Metropolitan Historic Zoning Commission
Sunnyside in Sevier Park
3000 Granny White Pike
Nashville, Tennessee 37204
Telephone: (615) 862-7970
Fax: (615) 862-7974

STAFF RECOMMENDATION
1618 Lillian Street
May 18, 2016

Application: New construction—Detached accessory dwelling unit (DADU); Setback determination

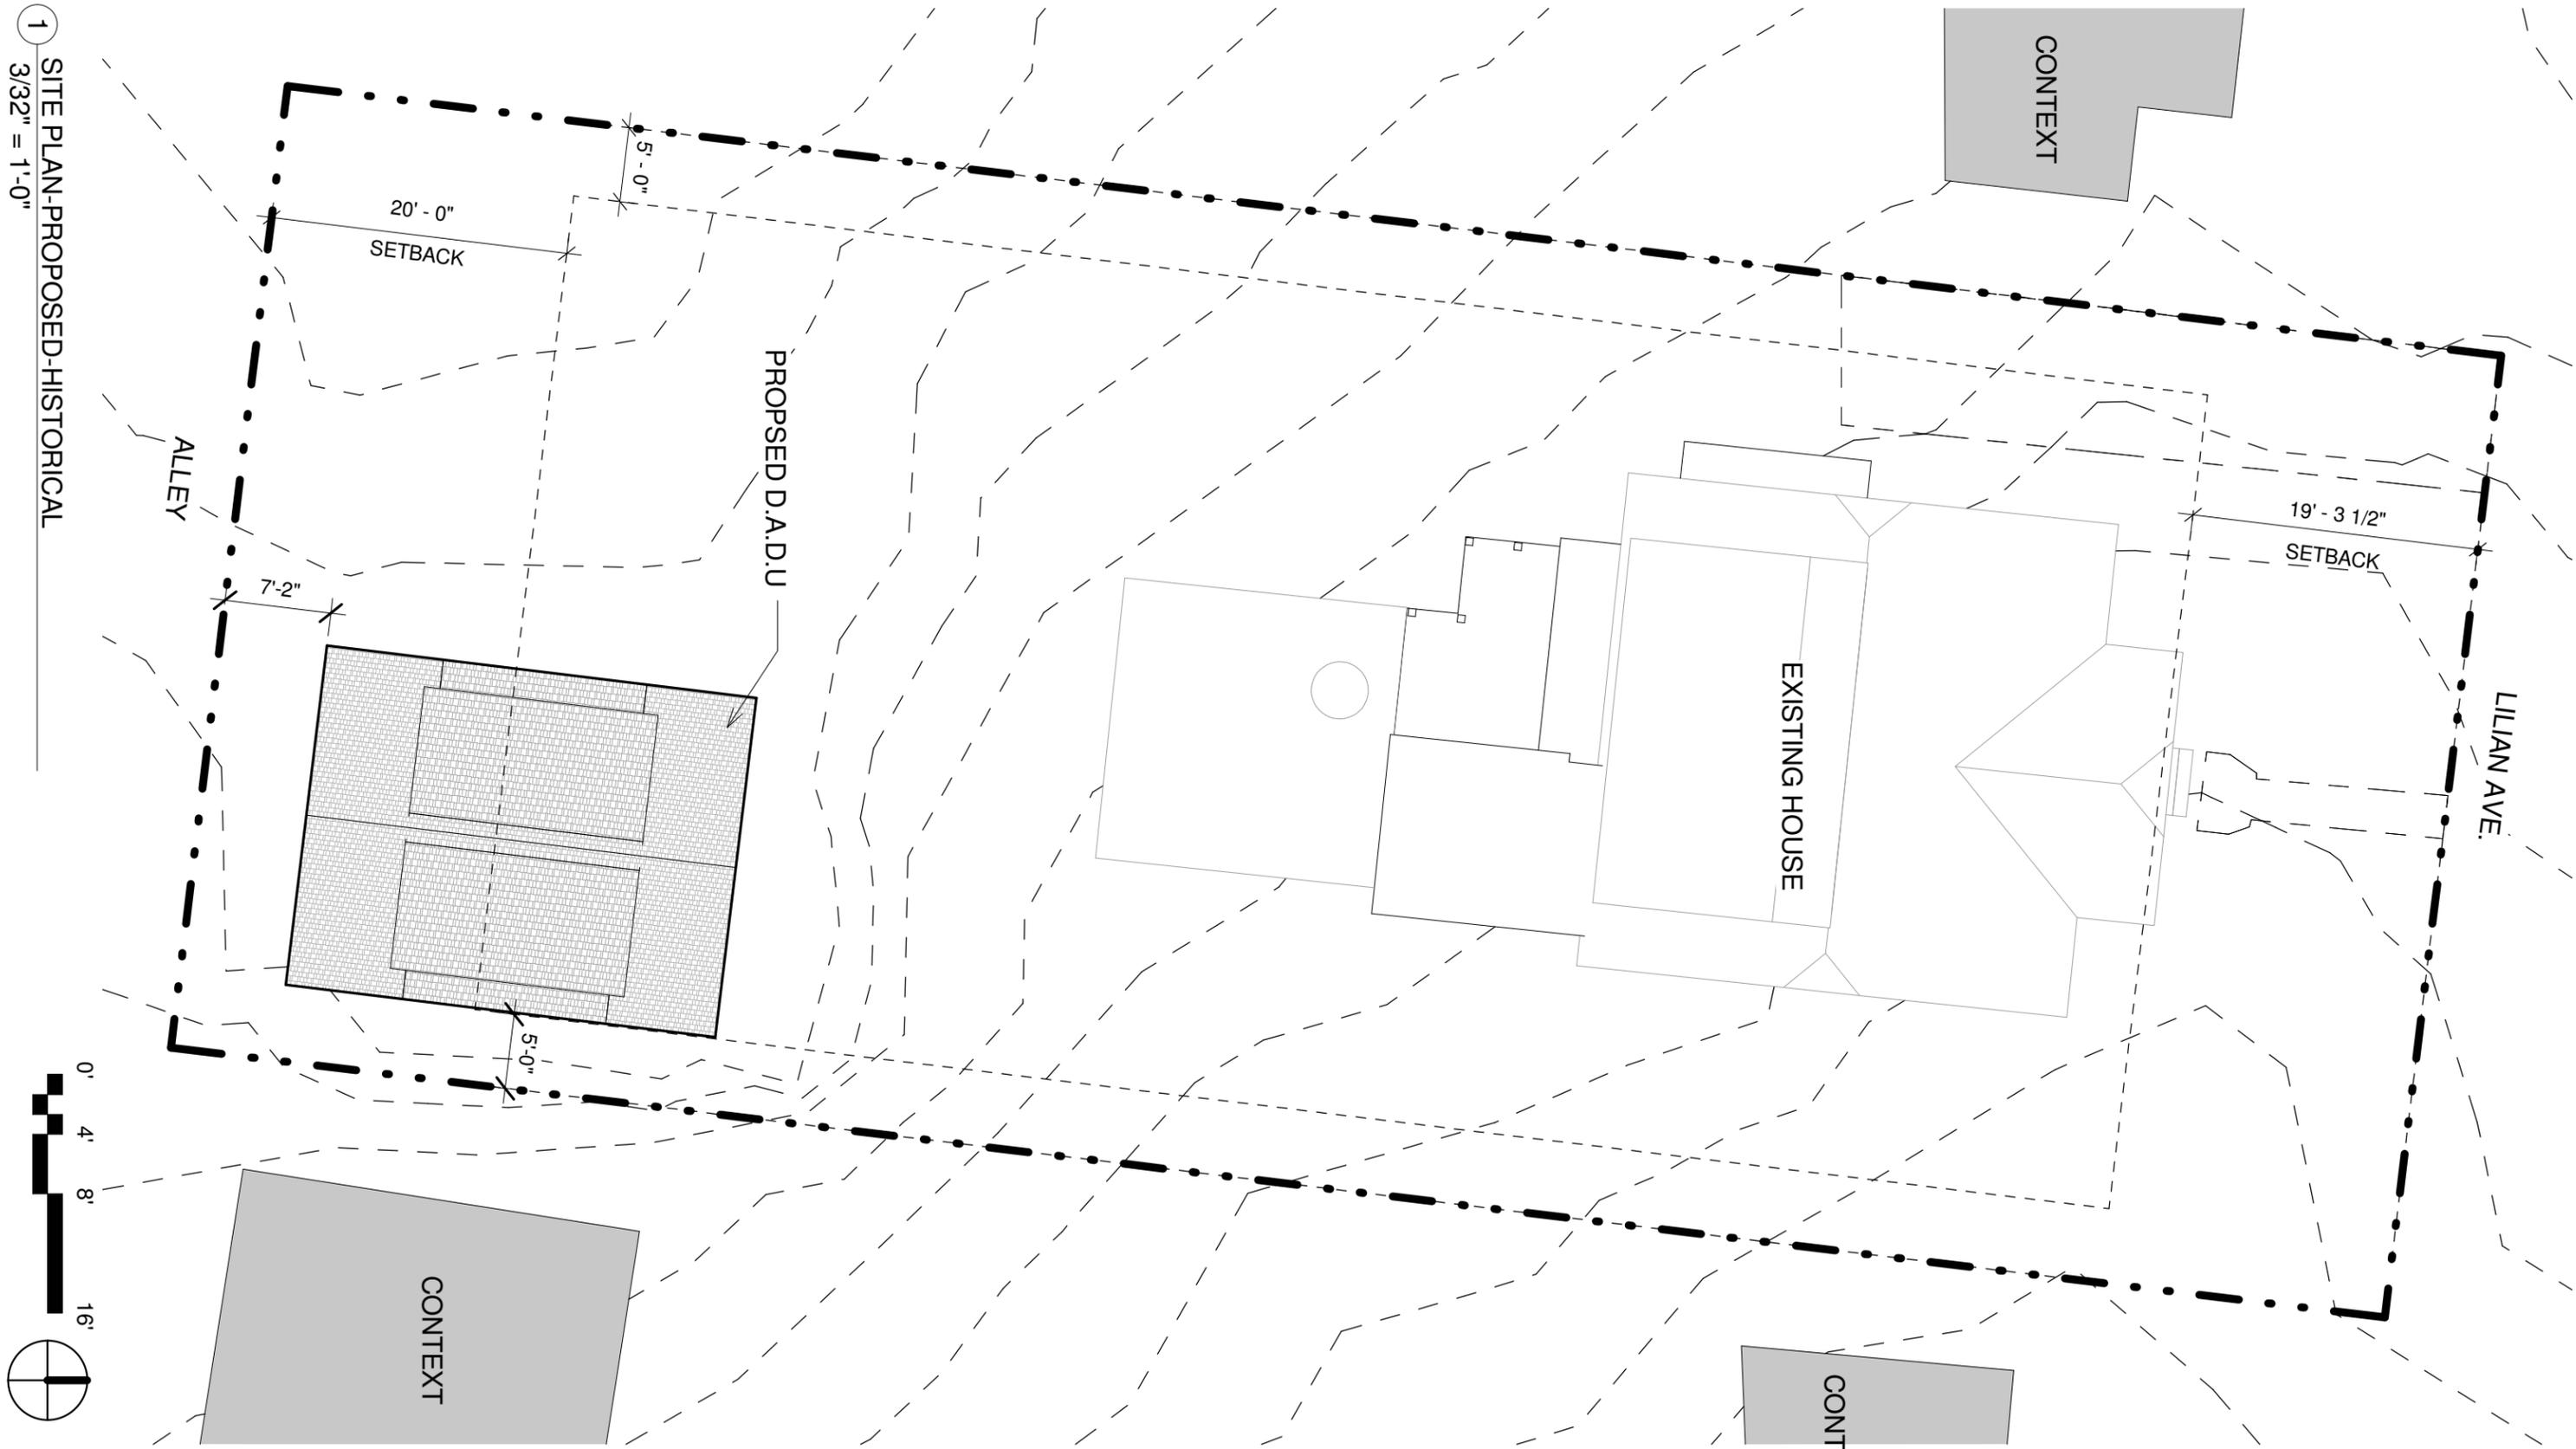
Base zoning states that an outbuilding with a footprint less than seven hundred square feet (700 sq. ft.) may be ten feet (10') from the rear property line and five feet (5') from the side property lines. This outbuilding meets the five foot (5') side setbacks, but does not meet the rear setback. The applicant is proposing to locate the outbuilding at a distance of nine feet, two inches (9'2") instead of ten feet (10') from the rear property line. There are several outbuildings nearby that are ten feet (10') or less from the rear property line. In addition, by placing the outbuilding closer to the alley, there is more space between the primary structure and the outbuilding, meeting the design guidelines' requirement for similar "open space" to the historic context. Staff recommends approval

of the rear setback determination.
